**Notes from a public meeting on the
WestConnex Stage 3 (M4-M5 Link)
Environmental Impact Statement (EIS)
held at Centurion Lounge, Leichhardt Oval
6:30-8:30pm Wednesday 4 October 2017**

Attention: Director, Infrastructure Projects, Planning Services Department of Planning and Environment, GPO Box 39, Sydney, NSW, 2001

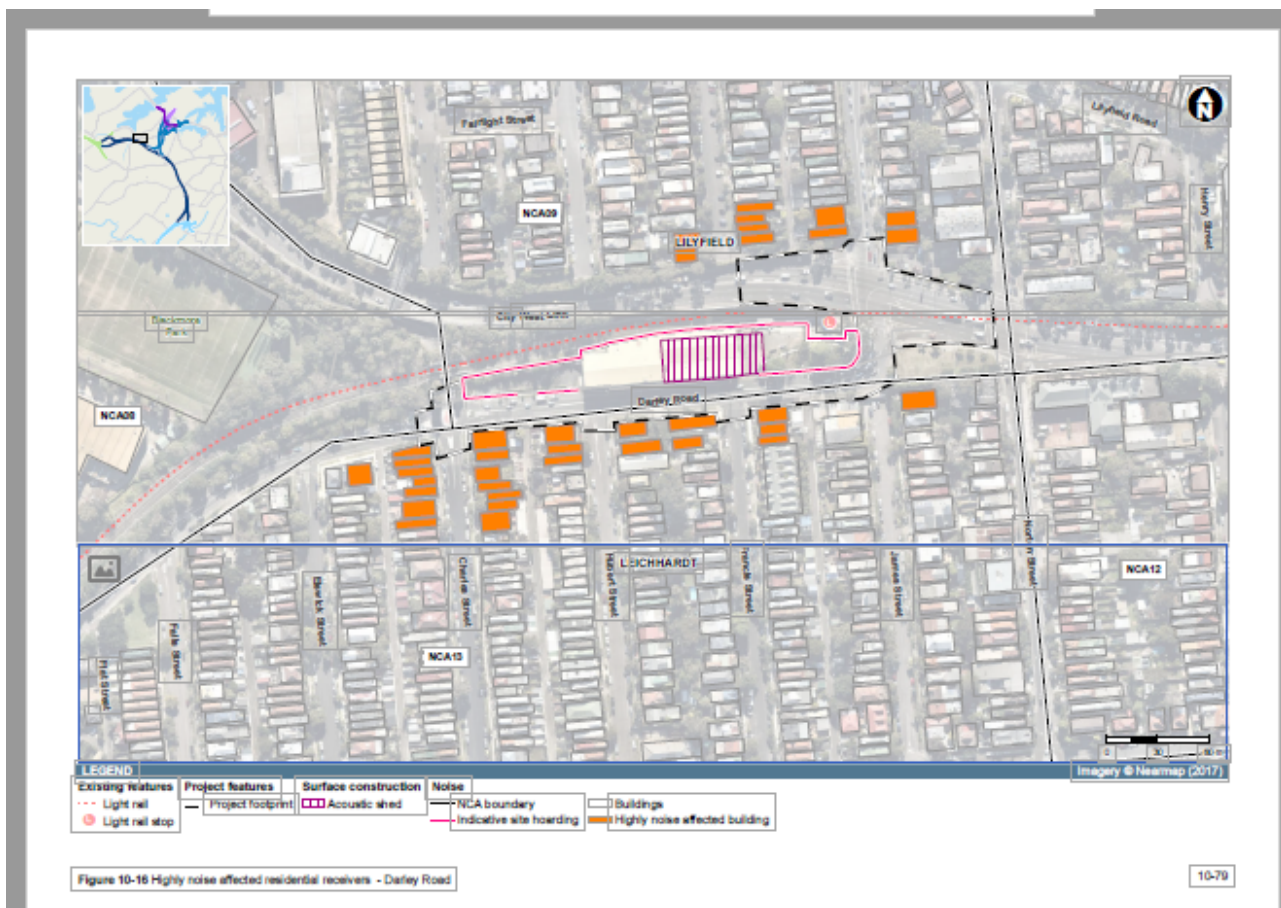
It is to be noted that RMS's modelling addresses the worst-case situation when the tunnelling is occurring immediately beneath a sensitive receiver. RMS admits that:

'Exceedance of the night-time criteria has been identified for sensitive receptors near key construction areas, specifically the Darley Road civil and tunnel site (C4) (with exceedance up to four dB (A)) and the Pymont Bridge Road tunnel site (C9) (with exceedance up to five dBA).'

Residents near the Darley Road dive site can therefore expect to be exposed to unacceptable impacts, yet very little information has been provided in this EIS about how RMS proposes to proactively manage these impacts. It must be a condition of approval that there be no exceedance of the night time criteria. We further object to the Darley Road civil and tunnel site (C4) at Leichhardt on the basis that:

- (a) There is no clear plan in the EIS for measures that will provide the maximum possible level of mitigation from noise impacts. We also object because there is no clear plan for remedies available to residents who are impacted.

Figure 6-20 Indicative Darley Road civil and tunnel site (C4) layout

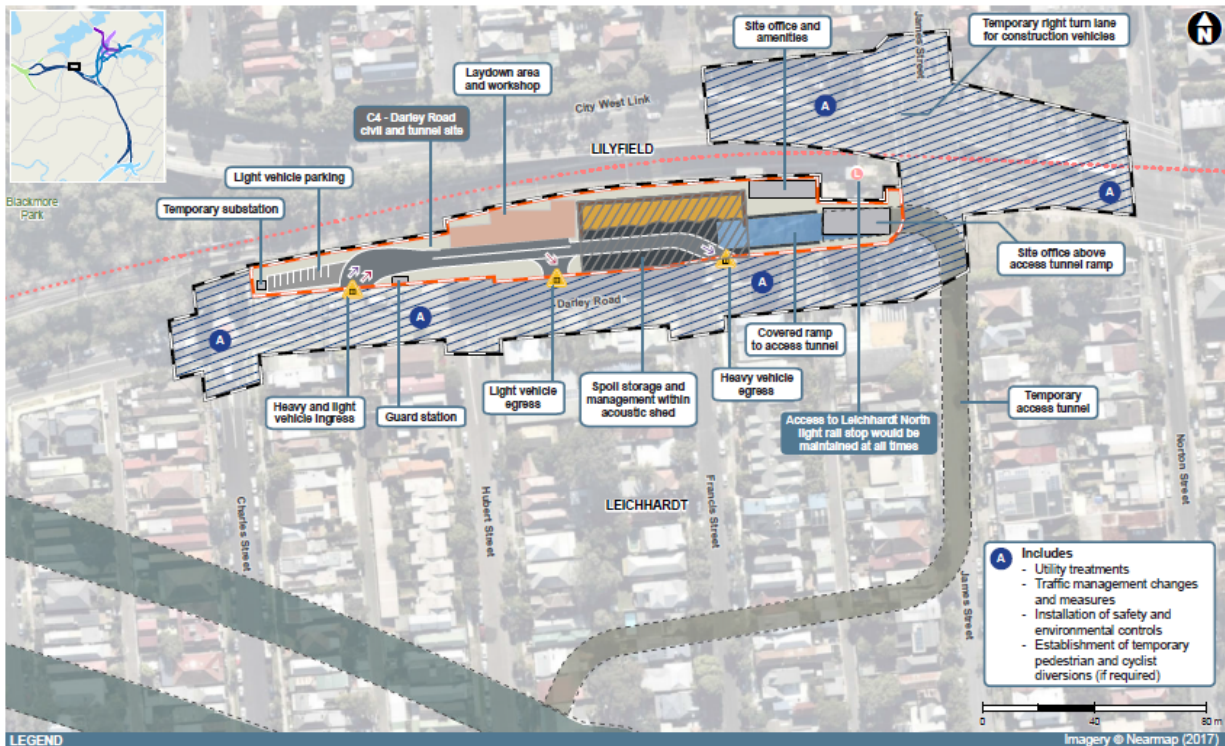
Darley Road civil and tunnel site (C4) will create a high level of noise impact for residents yet the proponent has not given details of the plan for mitigating this impact. The measures will be implemented only if 'reasonable and feasible' which is a subjective assessment as it does not state whether they will be assessed as reasonable from the standpoint of the proponent or the residents. What the proponent thinks is reasonable may not meet the residents' expectation as to what is reasonable. The measures appear to be optional as the proponent only states that that *'may include noise barriers and other temporary structures such as site buildings'*.

- The proponent has not provided a clear plan for measures that will be taken to minimise noise impacts from work within and outside of standard construction hours at the Darley Road civil and tunnel site (C4) at Leichhardt.
- The proponent has failed to take account of the fact that the demolition of the Dan Murphys building will remove a significant barrier to traffic noise from the City West Link. This will mean increased traffic noise impacts to the residents of Darley Rd, Francis St, Hubert St and Charles Street.

- The proponent has failed to take account of the noise impact of fully laden spoil haulage trucks exiting the Darley Road civil and tunnel site (C4) at Leichhardt driving up the very steep blind turn at the intersection with the City West Link. The RMS should install noise measuring equipment and monitoring cameras at this location to measure noise from heavy vehicles and identify vehicles whose noise that exceeds the applicable Australian standard.

- The proponent has failed to take account of the noise impact of spoil haulage trucks using air brakes on the descent down Darley Rd off the City West Link. Heavy vehicle drivers should avoid using exhaust brakes, engine compression or 'jake' brakes near residential areas and noise-sensitive areas such as hospitals and schools, unless they are necessary for safety reasons. RMS should implement noise limits from engine compression brakes and should use roadside noise 'cameras' as an aid to enforcement as vehicles emitting engine compression brake noise might affect nearby communities.

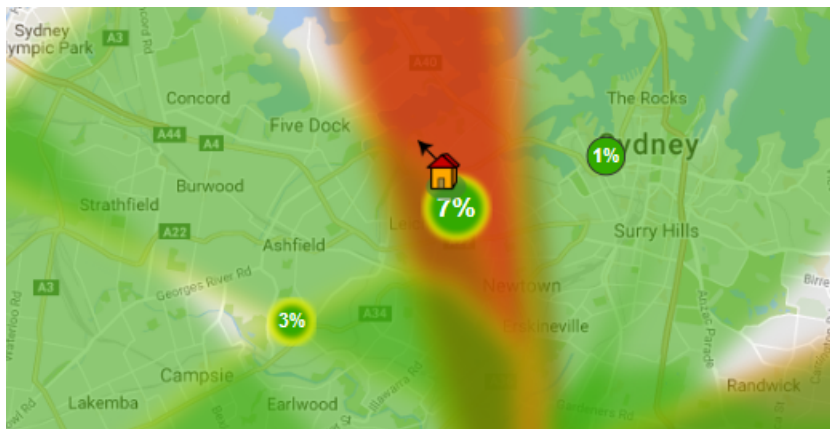
- Use of a rock breaker during the daytime period as part of the demolition works and
- Use of a road profiler during the night-time period as part of the road adjustment works

We object to the EIS because the proponent provides that spoil handling works within the acoustic shed will take place for the duration of the construction phase which could be up to two to three years duration, yet there is no clear plan for measures that will be taken to minimise noise impacts.

We object to the Darley Road civil and tunnel site (C4) on the basis that there is no clear plan in the EIS for measures that will provide the maximum possible level of mitigation from noise impacts. We also object because there is no clear plan for remedies available to residents who are impacted.

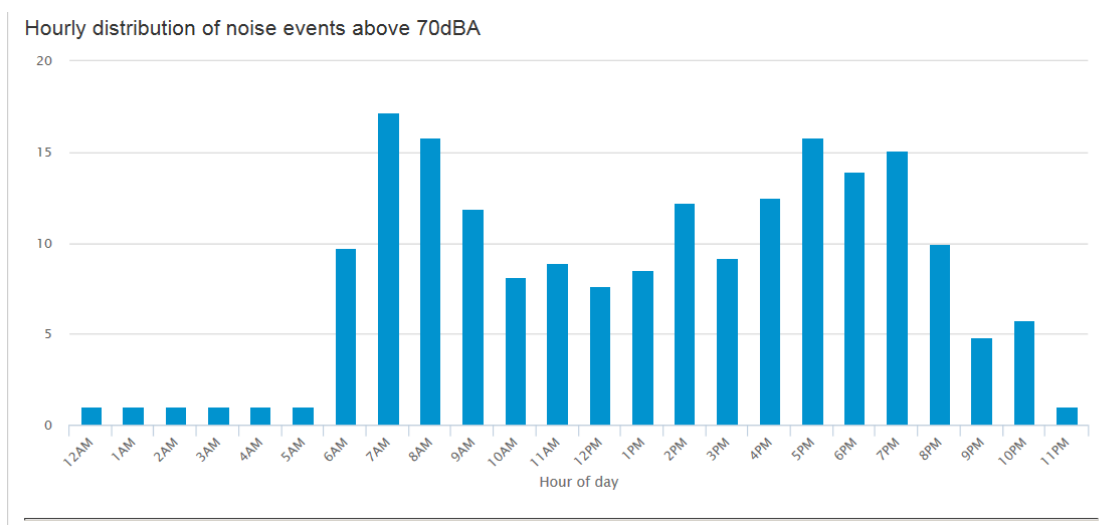
We object to the EIS because the proponent has failed to take account of the cumulative impact of its proposed Darley Road, Leichhardt civil and tunnel site operations and the aircraft noise which the residents near the site already endure. The extract from Webtrak (**below**) shows that Darley Road, Leichhardt and adjacent streets are directly under the flight path.

Airservices Australia reports that in April to June 2017 the number of average daily noise events over 70 dBA. In Leichhardt this is an average of 16- 17 per hour over the peak morning period and 16 per hour in the early evening peak period.

The above extract from Webtrak shows that Darley Road, Leichhardt and adjacent streets are directly under the flight path.

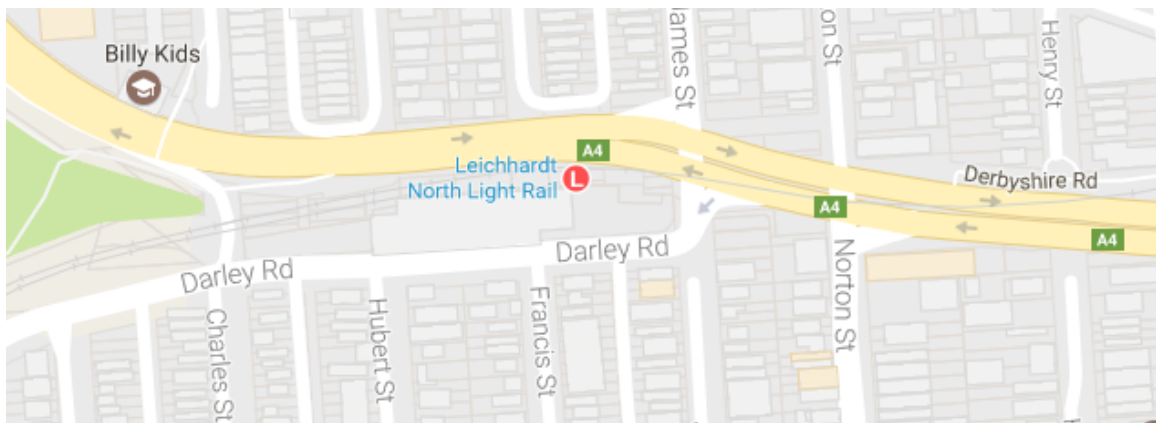
We object to the location of the Darley Road civil and construction site because the site cannot accommodate the projected traffic movements without jeopardising the road network. Darley Road is a critical access road for the residents of Leichhardt and the inner west to access and cross the City West Link. It is already congested at peak hours and the intersection at James Street and the City West Link already has queues at the traffic lights. The only other option for commuters to access the City West Link is to use Norton Street, a two-lane largely commercial strip which is already at capacity. The addition of hundreds of trucks and contractor vehicles will result in traffic grinding to a halt and traffic chaos at this critical juncture with commuter travel times drastically increased.

See image **below** which depicts the location of Darley Road and Norton Street relative to the City West Link:

Figure 6-28 Indicative spoil haulage route – Darley Road civil and tunnel site (C4)

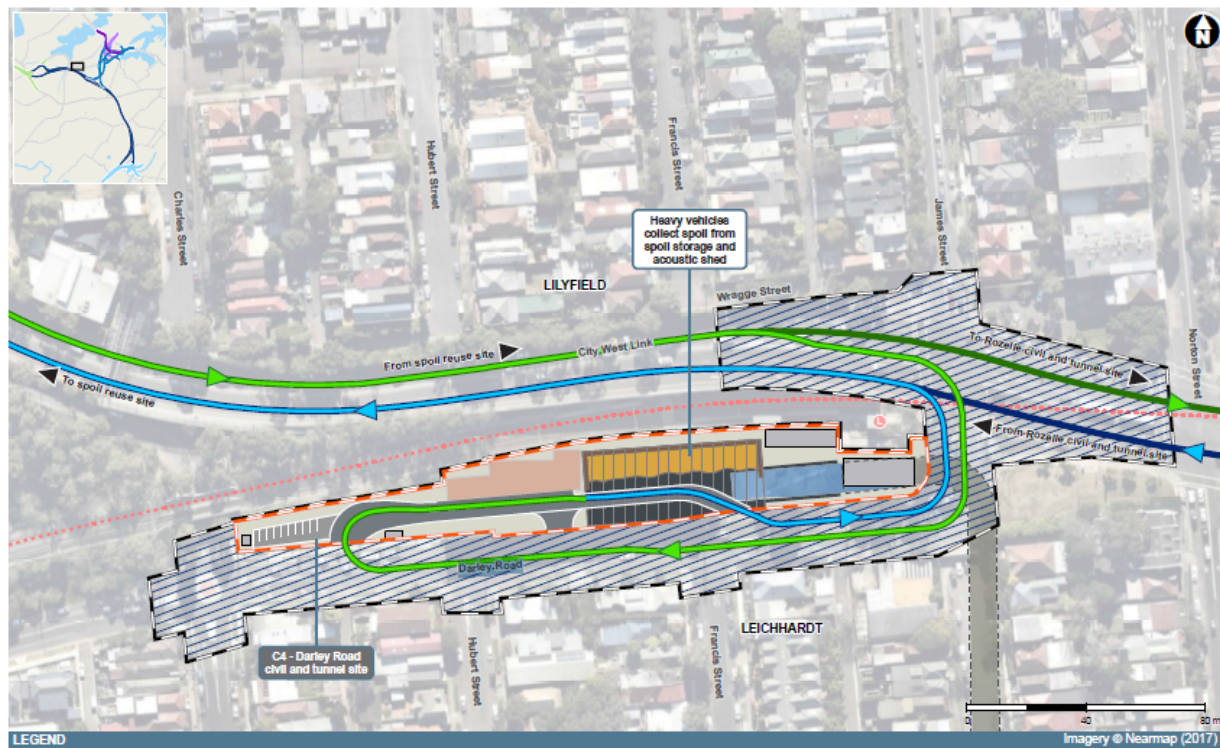
The EIS states that a Construction traffic and Access Management plan (CTAMP) would be prepared to minimise delays and disruptions and identify changes to ensure road safety. The plans are not in the EIS so residents cannot comment. What guarantee is there that the plan will be effective? The EIS should be rejected on the basis that the impacts on traffic and safety are not adequately addressed. It is also inadequate to simply refer to a plan, with no provision for residents and other key stakeholders to be involved in its development and no assurance it can work.
